**RESPONSE REGARDING OVERSHADOWING OF VEGETATION AT
HANSON SITE: HONEYCOMB DRIVE, EASTERN CREEK**

The purpose of this letter is to present a response to comments provided by Blacktown Council regarding the proposed modification to the Hanson site (Lot 5, DP 1145808) at Honeycomb Drive, Eastern Creek (hereafter referred to as the 'subject site').

RETAINING WALL PLAN
SCALE 1:1000

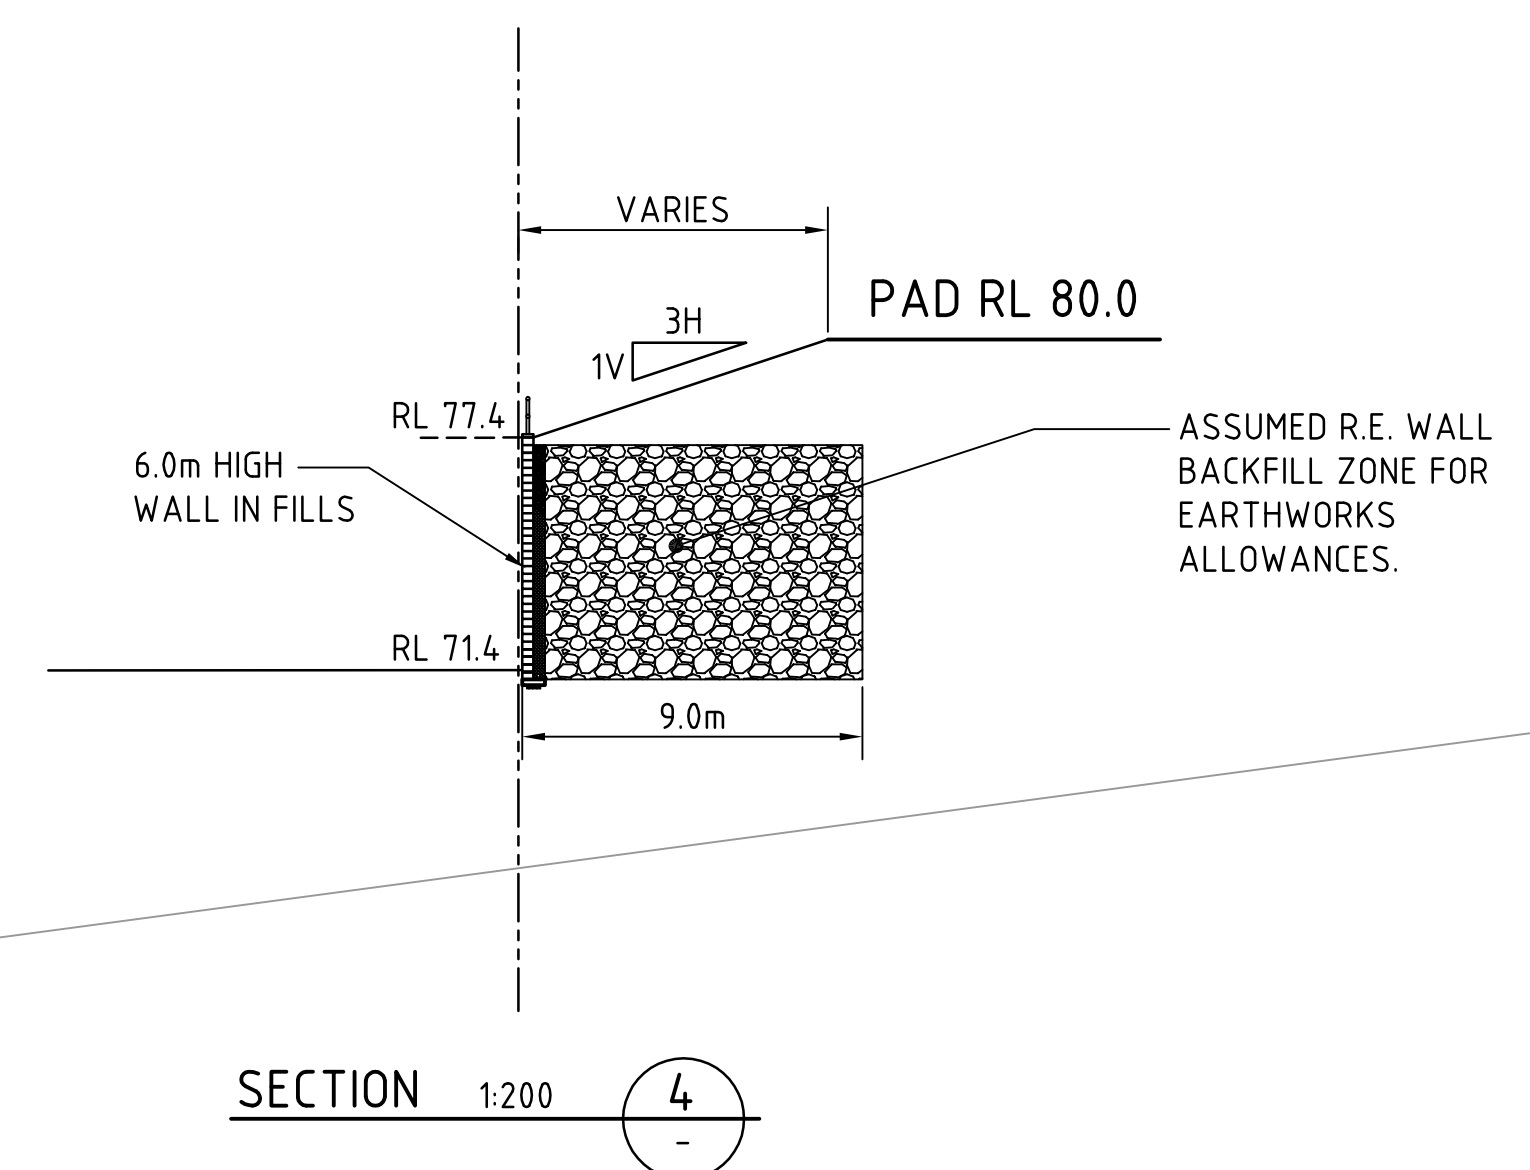
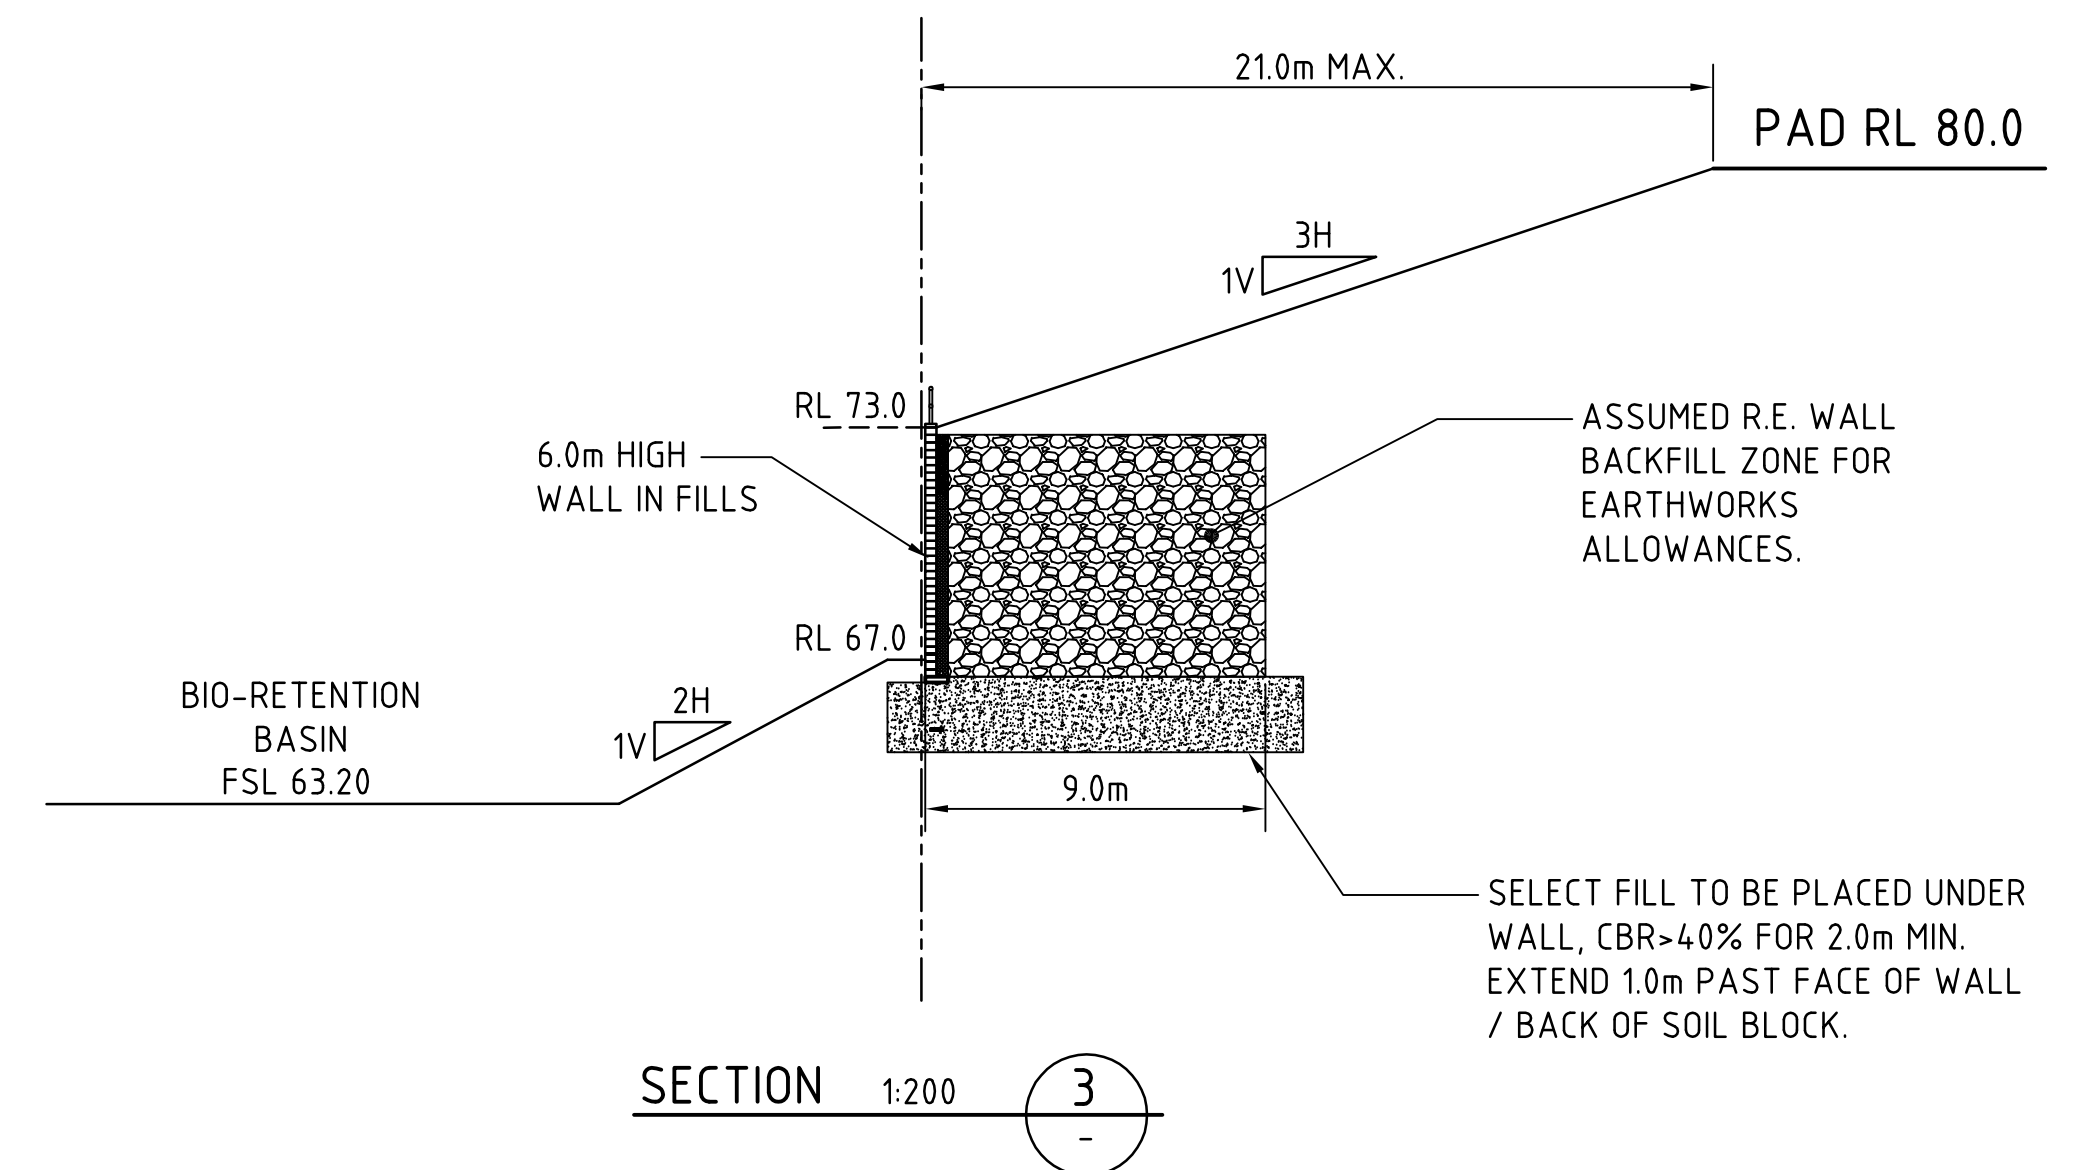
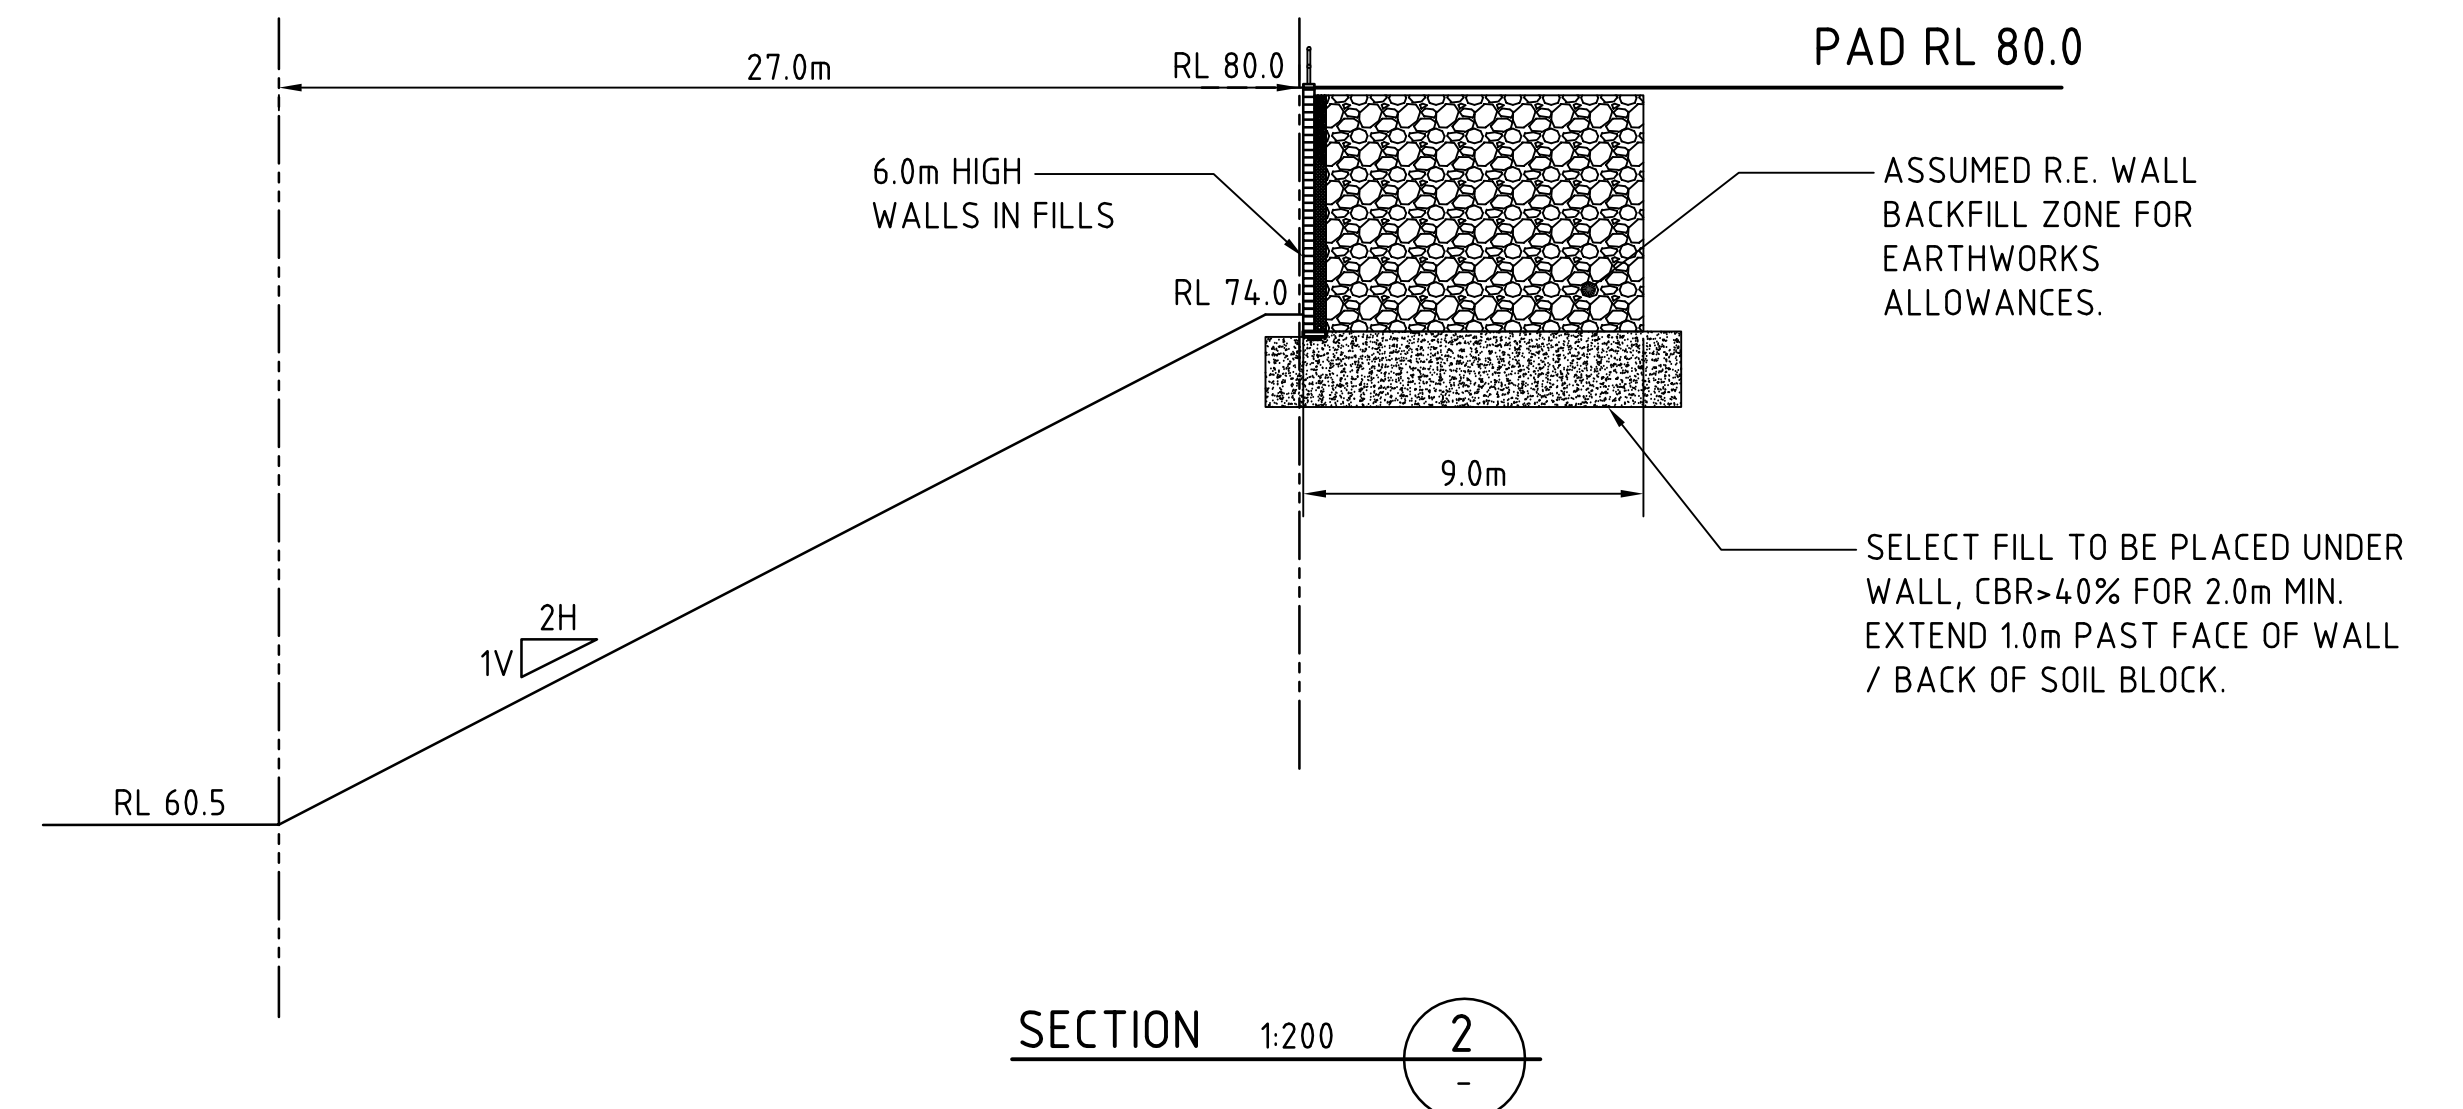
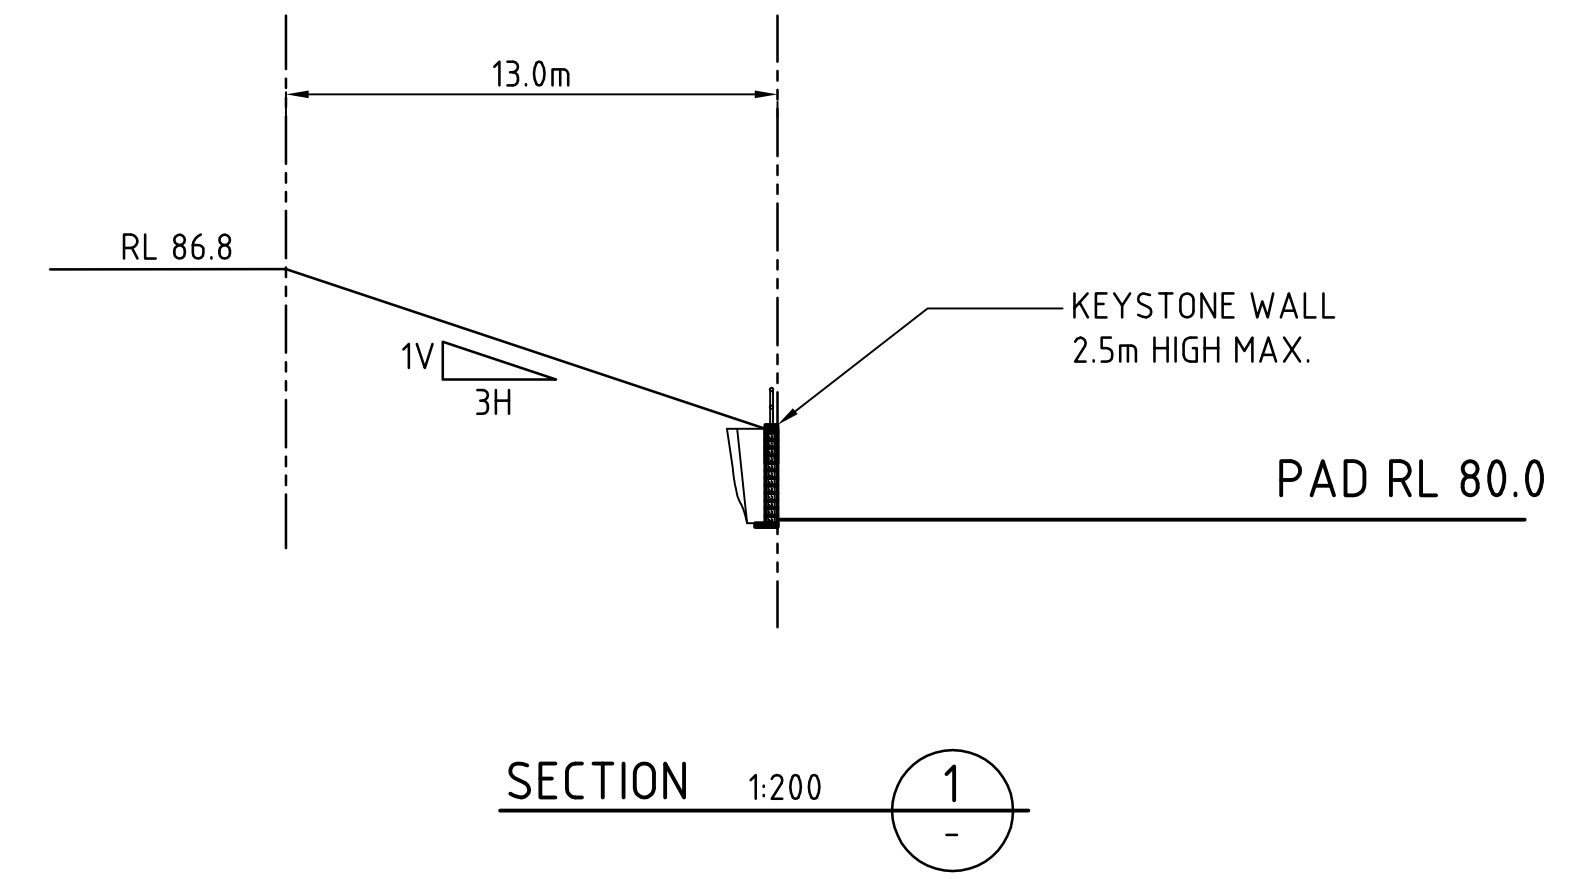
The proposal indicates that the proposed retaining walls on the vicinity of the proposed revegetation area along the western boundary of the subject site are of a substantial height, of up to 6m to the west of the Australand

Purchase Area and the Basin. In most cases the battering is also quite steep.

Concern is raised that the substantial change in levels will result in substantial overshadowing of the proposed revegetation areas and its viability. This will be further exacerbated by the future building forms on the site.

The Proponent is requested to consider the viability of this vegetation if the opportunity for access to sunlight is limited.

The proposed retaining wall is shown in a third figure, the retaining wall layout plan, reproduced in **Appendix A**. The retaining wall in question is retaining wall 2, which would be 6 m high and have a west sloping batter approximately 30 metres wide.

We note that the batter slope of retaining wall 2 will be shaded in the mornings but will have sunshine in the middle of the day and during the afternoons.

In assessing the impacts of shading on proposed CPW plantings, it is important to note that overshadowing can and does occur naturally in CPW. Where large mature trees and/or shrubs are growing close together more than 40% of sunlight can be intercepted by the tree canopy, and more by larger shrubs beneath it. Notwithstanding that, in such circumstances, understorey and ground stratum plant species can still occur.

As CPW trees become established and grow taller, their canopies will eventually exceed 20 metres in height. As such, the trees to be established will substantially overtop the retaining wall in the future and will not be impacted by shading from it when trees mature.

We have also worked on sites where CPW grows on steep slopes comparable to the batter slope, as it does in places such as the nearby Marrong Reserve, Greystanes Estate. Under such circumstances, trees, shrubs, grasses and other herbaceous native plants from CPW are viably established. For this reason, we believe that CPW plantings, as proposed, are likely to be successful provided adequate soil is provided on the batter for the retaining wall.

In summary, we believe that overshadowing will not significantly affect the viability of the proposed revegetation areas. However, we recommend that any plantings are carefully tended and monitored until viably established.
